HITCH RACK RANCH QUARRY

M-2017-049

Subject: Responses to Preliminary Review of 112 Permit Application for Transit Mix Concrete Company, Hitch Rack Ranch Quarry, M-2017-049

RESPONSES TO FILING DEFICIENCIES ON HITCH RACK RANCH QUARRY PERMIT APPLICATION M-2017-049

PLAN VIEW AND CROSS SECTION LOCATIONS

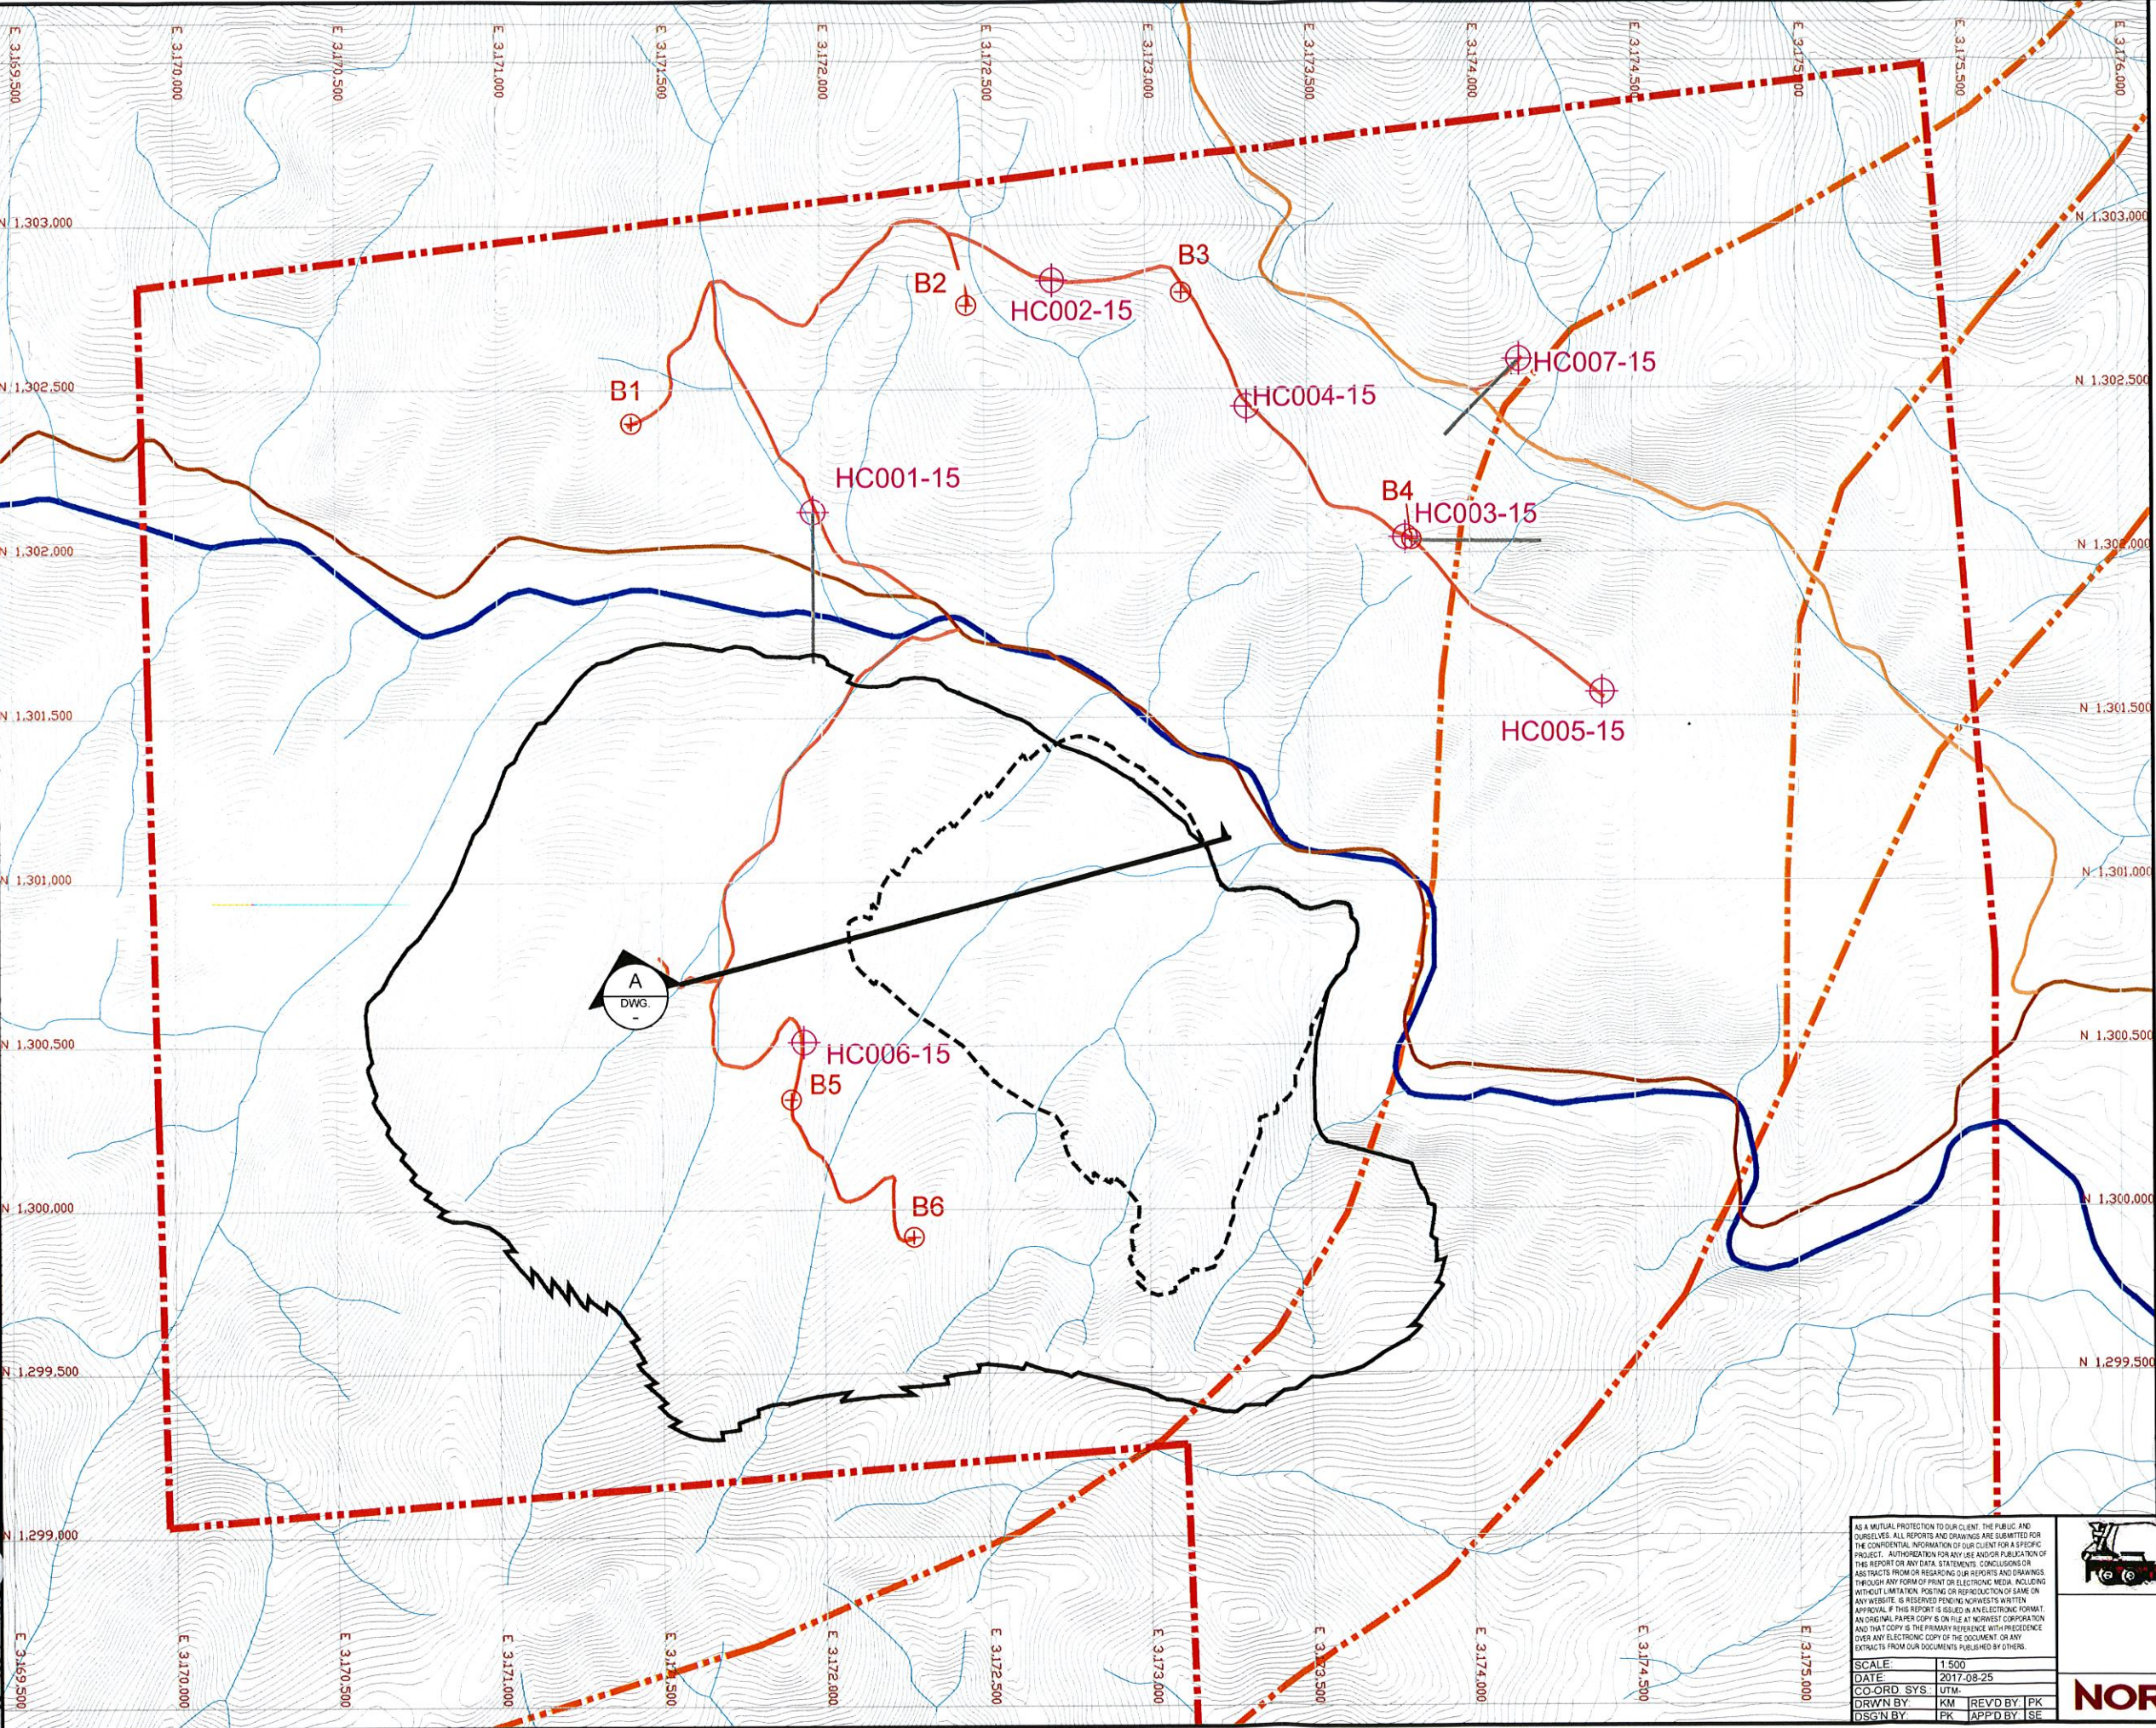
- 23) **Comment:** In the original application, the first two figures following page 17 of the Norwest Corporation Memorandum regarding Hitch Rack Ranch Pit Wall Geotechnical Assessment -Rev. 0, are not provided, but were provided with the copies of the application. In the original application, portions of the figures were submitted on letter-sized paper rather than as complete, full-size maps. These two figures are titled “Plan View and Cross Section Locations” and “Geophysical Survey Results”. Please submit complete copies of these figures to satisfy the requirements of Rule 1.4.5(2)(b).

Response: Full-scale maps have been included with this submittal.
